SUNDRY NOTICES AND REPORTS ON WELLS

| Do not use the | is form for proposals to II. Use form 3160-3 (API | drill or to re-enter ar | s. FEB 232 | 012 6 If Indian, Allottee | or Tribe Name |
|---|--|---|--|--|---|
| Type of Well | ner. INJECTION | | | 8. Well Name and No MCA UNIT 485 | |

Order of the Authorized Officer

Conoco Phillips Company MCA Unit 485 API 3002539403

Schematic - Current

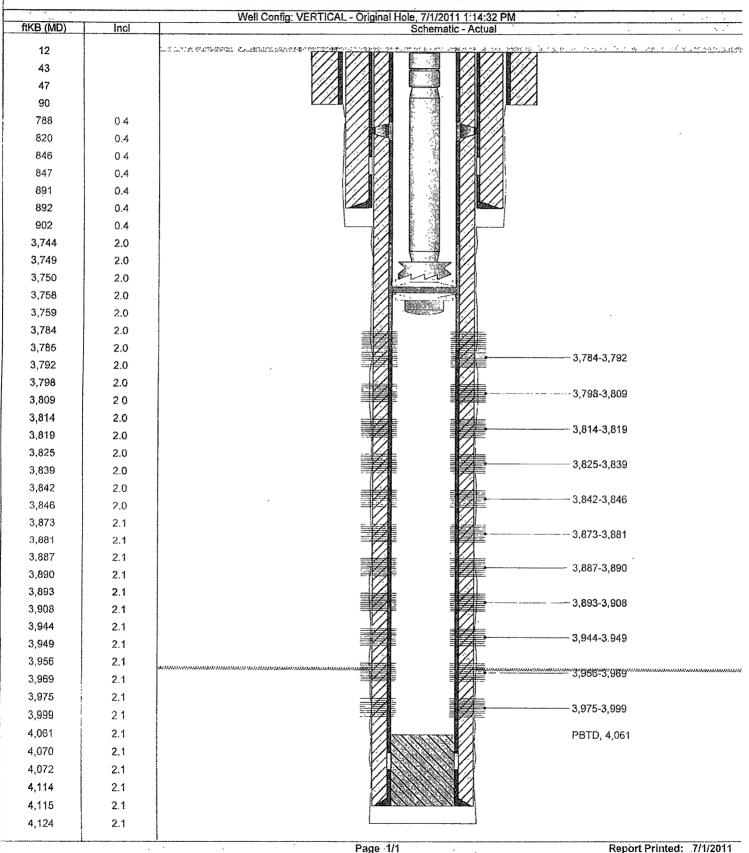
- 1) Conduct a Mechanical Integrity Test of the tubing/casing annulus after a tubing, packer or casing seal is established. Repair that seal any time more than five barrels of packer fluid is replaced within 30 days.

- a) The minimum test pressure should be 500 psig for 30 minutes or 300 psig for 60 minutes, with 200 psig differentials between tubing and casing pressure (at test time) but no more than 70% of casing burst pressure as described by Onshore Order 2.III.B.1.h. (The tubing or reservoir pressure may need to be reduced). An alternate method for a BLM approved MIT is to have the fluid filled system open to atmospheric pressure and have a loss of less than five barrels in 30 days witnessed by a BLM authorized officer.

- e) Use of tubing internal protection, tubing on/off equipment just above the packer, and an in line tubing check valve below the packer or between the on/off tool and packer is required. The setting depths and descriptions of each are to be included in the subsequent sundry. List (by date) descriptions of daily activity of any previously unreported wellbore workover.
